Project Location:	500 Kirkham Street. The property is bounded by 7 th Street, Union Street and 5 th Street and is located near the West Oakland BART Station.
Assessor's Parcel Numbers:	004 004900100, 004 004900301 & 004005101802
Proposal:	To construct two detached eight and nine-story buildings and one detached 23-story building consisting of 1,032 residential units with ground-floor retail and flex space commercial areas, surface parking lot for eight parking spaces, courtyards, roof deck, terraces, pedestrian commercial pathways including an amenity and outdoor pop-up retail space.
Project Applicant/ Telephone:	Zac Shore, Panoramic Interests / (415) 701-7002
Property Owner:	500 Kirkham, LLC
Case File Number:	PLN17428/ PUDF07
Planning Permits Required:	Conditional Use Permits for Planned Unit Development (PUD); Regular Design Review for new construction; and Tentative Parcel Map Subdivision to subdivide three new parcels.

SUMMARY

CITY OF OAKLAND PLANNING COMMISSION

Case File: PLN17428 / PUDF07
Applicant: Panoramic Interest, Zac Shore
Address: 500 Kirkham Street
Zone: S-15W
Height Area: 160 ft

SHEET NUMBER
G0.7

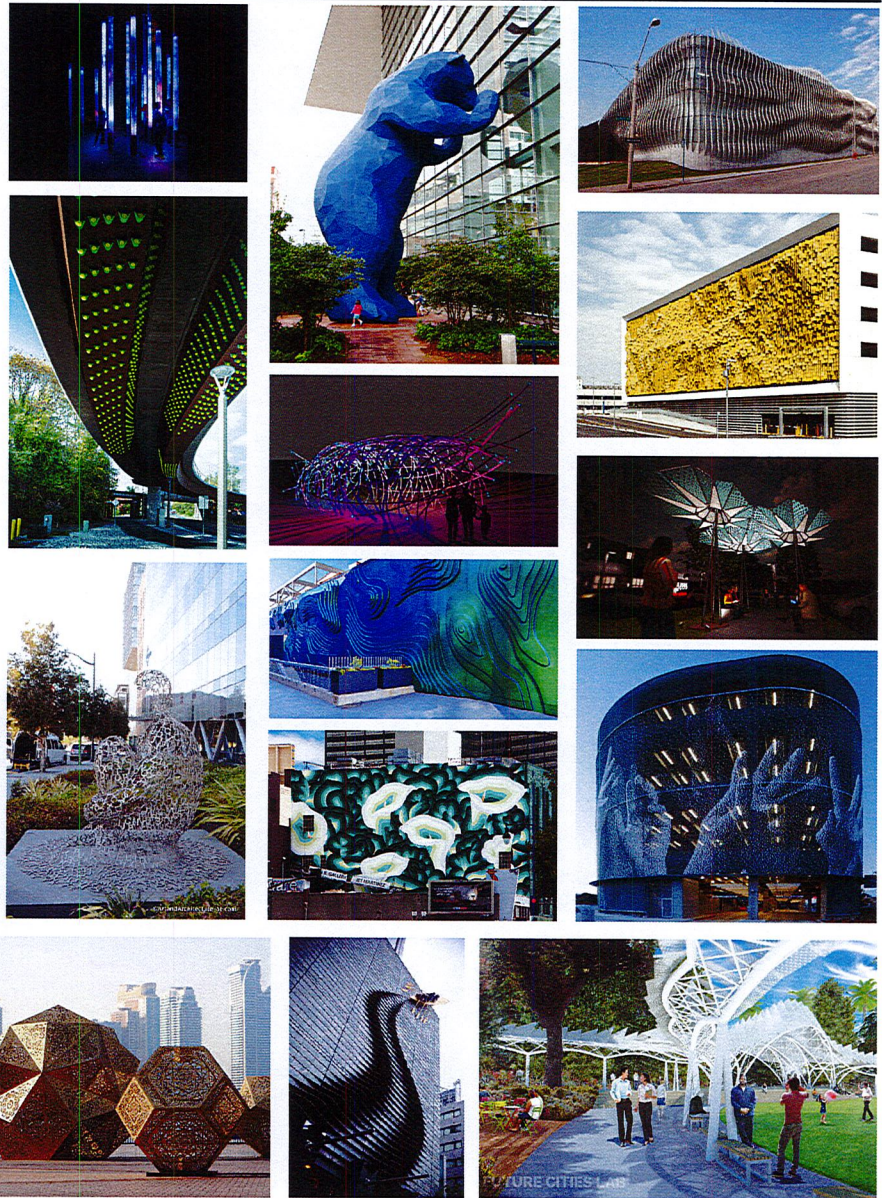
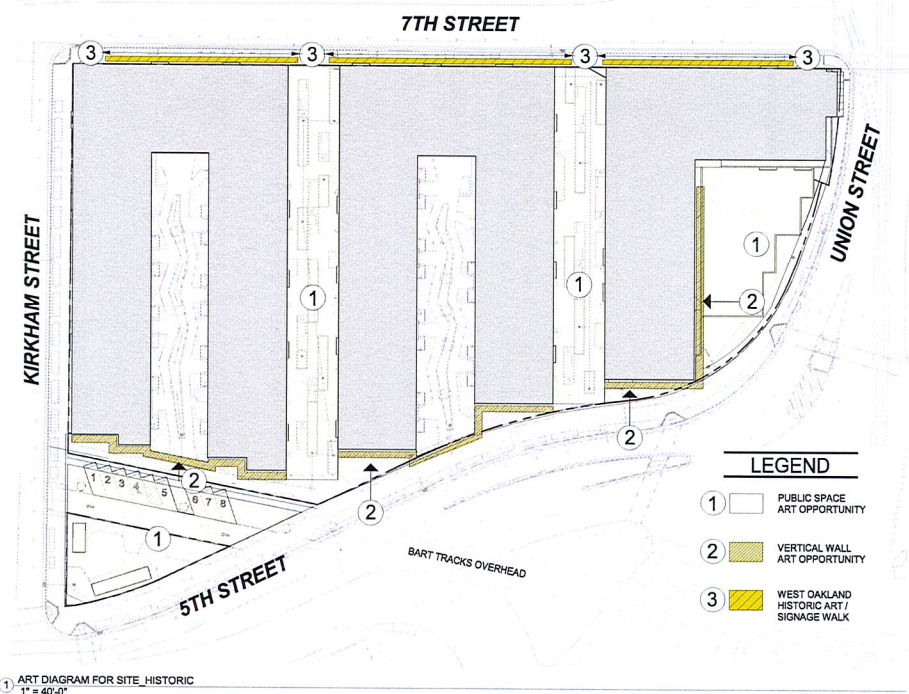
The project includes design concepts for public art within the "community gathering" pedestrian pathways and along the south and east facade of the buildings. The proposed public art range from images and other creative elements or structures. The applicant also proposes additions and/or modifications to the West Oakland Historic Art signage walk along 7th Street. These existing art works derive from the City's 7th Street Concept and Urban Design Plan by Walter Hood adopted in 2004. The intent of the Plan is to provide recommendations to reduce impacts of transportation, primarily on the 7th Street between Wood and Union Streets. The plan also recommends amenities conducive to future transit oriented development and activity with emphasis on creating a strong civic character for identity. See pages G0.7 & G0.7.1 of the design plans for details.
